Tasman Resource Management Plan PC76: Wakefield Growth Plan Change

**Report prepared to fulfil the requirements of Section 42A of the
Resource Management Act 1991**

May 2024

Figure 13: Proposed PC76 Zoning Update Zone Map 76/2.

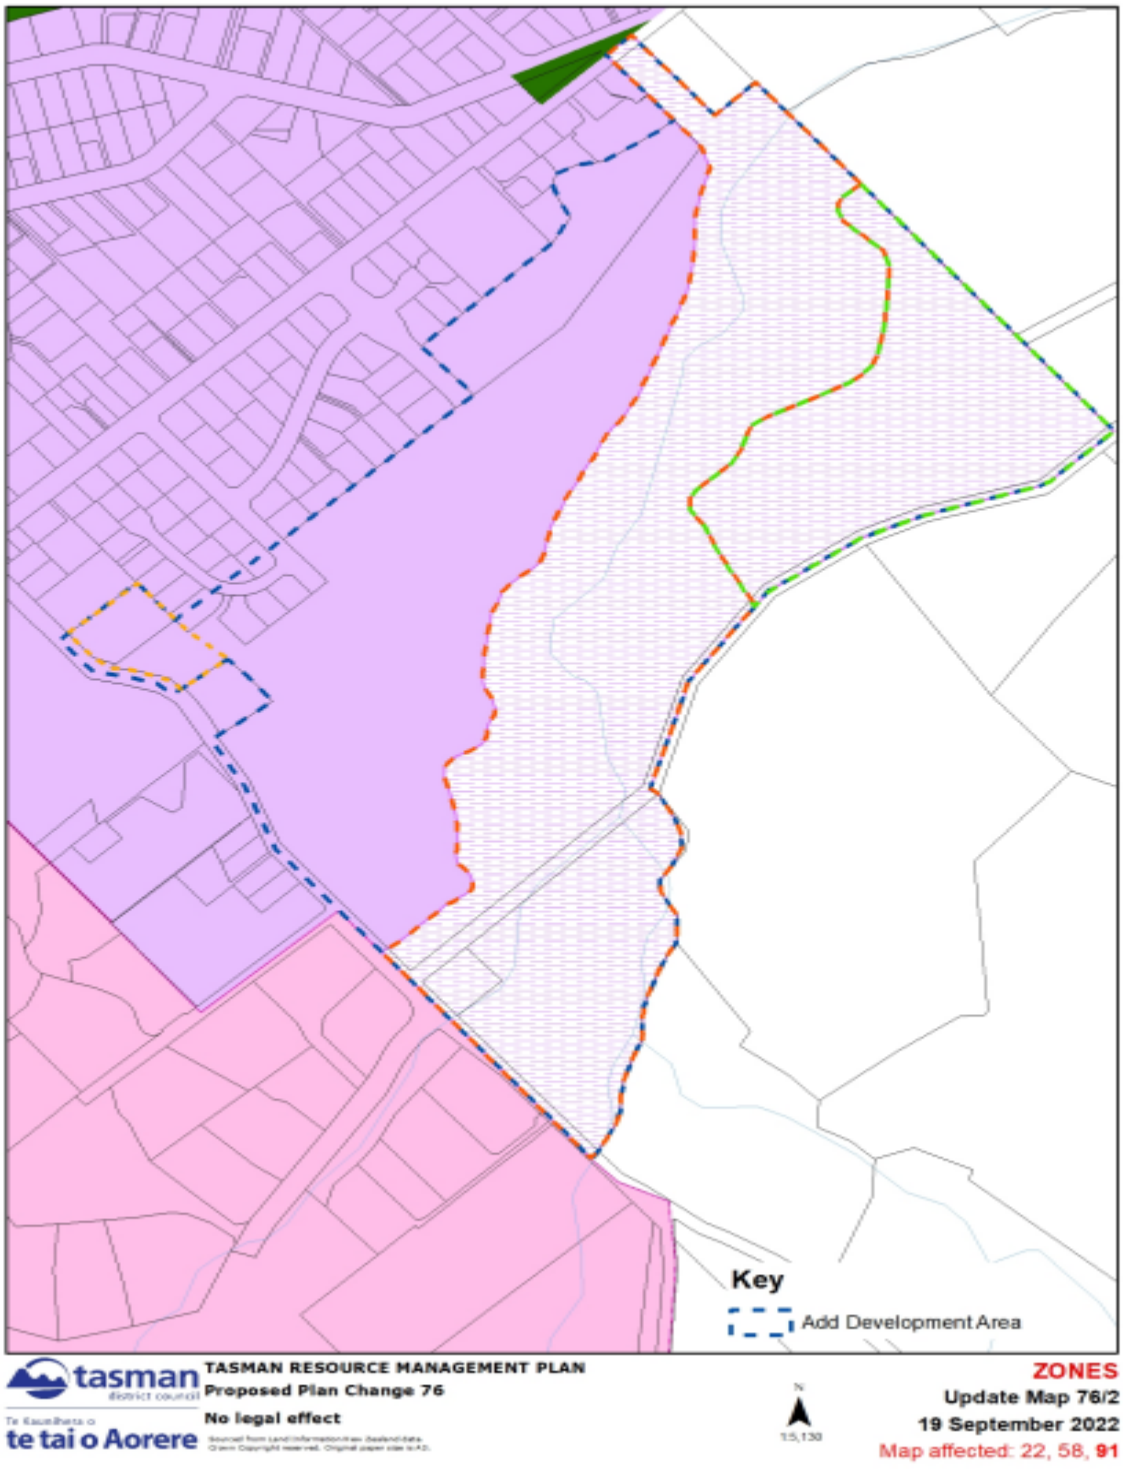
to residential. It is currently Rural 2 and proposed to be 'Rural 2 deferred Residential' under the notified PC76 (Figure 13).

In the northern part of the development area it is a logical to amend the zoning to align with the topography of the site and prevent the spilt zoning of land particularly where the area of additional land is minimal. It should be noted that there is currently no wastewater servicing capacity for development on the residentially zoned land (or the supported extension to the residential zoning). Wastewater servicing is however included in the Councils 10 Year Plan.
